# ACCESS ASSESSMENT REPORT (SEPP SENIORS)

*Castle Cove Golf Club – 68 Deepwater Rd, Castle Cove  
NSW 2069*

Project Number: 117017

Date: 7 December 2023

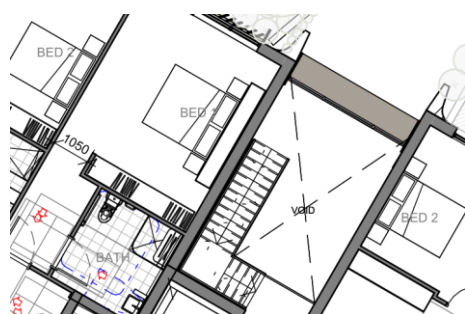
- The following stairway is required to be revised to ensure handrails do not protrude into the transverse path:
  - Stair handrail in lift lobby – applicable to entire development

Stair – Lower Ground

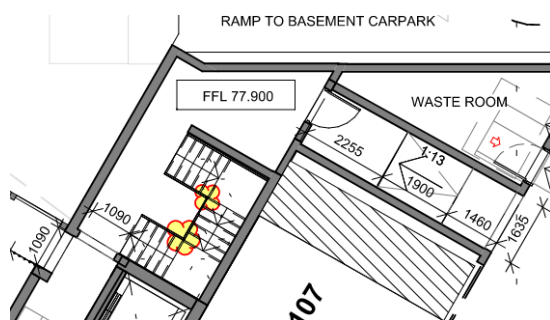
Please ensure that the following stairways do not have vertical sections on the handrails.

Basement

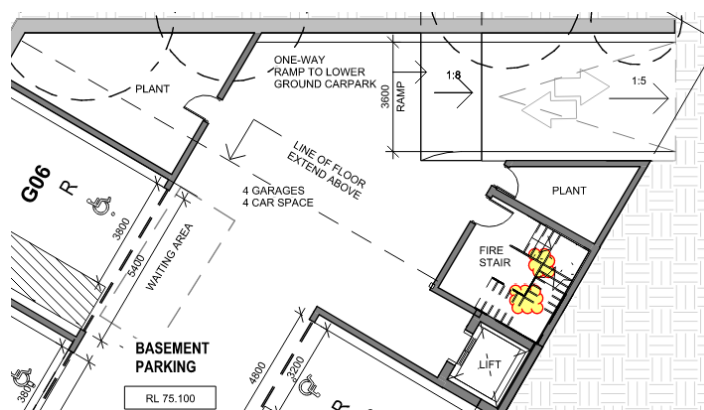
- a single continuous handrail
- off set at the bottom of each flight of stair to mitigate vertical handrail sections

### Entry Stair

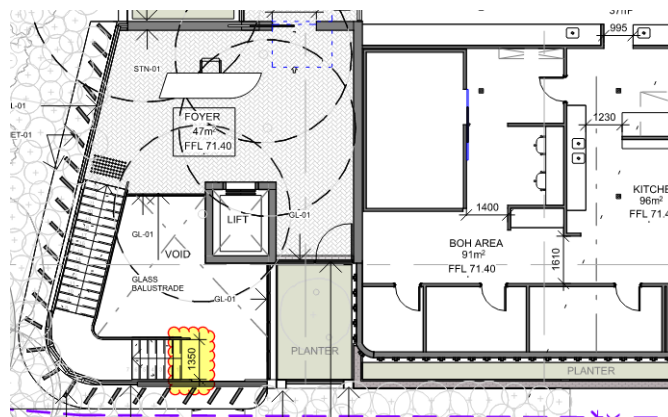
Please ensure the entry stair handrail and TGSi set out do not protrude into the door entryway. The first flight of stairway is to be relocated west on the document. This is intended to be carried out during post DA coordination.

### Northern carpark stairway

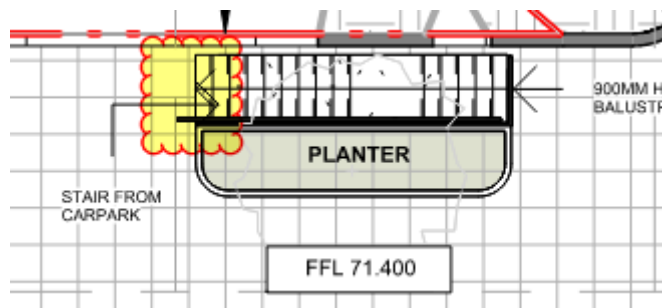
If this stairway is intended to have a dual role of being both an egress and general access stair. Full compliance AS1428.1-2009 is required to be provided:

- Two handrails with extensions and termination at the top and bottom of the stairway – ensure handrail extensions do not protrude into the transverse path.
- TGSIs at the top and bottom of the stairway

### Fire Stairs

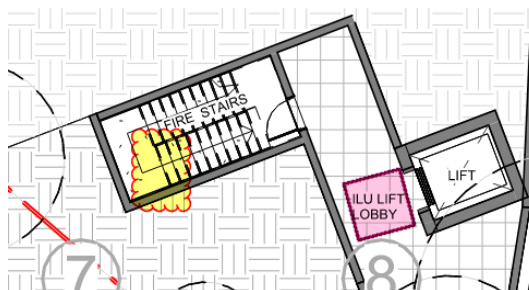
The following fire stairs are required to have the bottom step of each flight off set to mitigate provision of vertical sections to the handrails at the mid landing. This level of detailed information can be carried out during post-DA coordination.

### Walkways

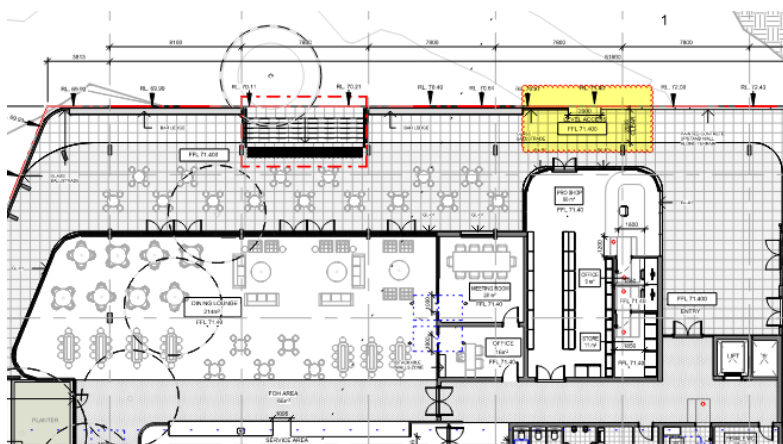
It is noted on the current documents that equitable access is provided off the terrace dining area via a level access located circa 1500mm from the stairway.
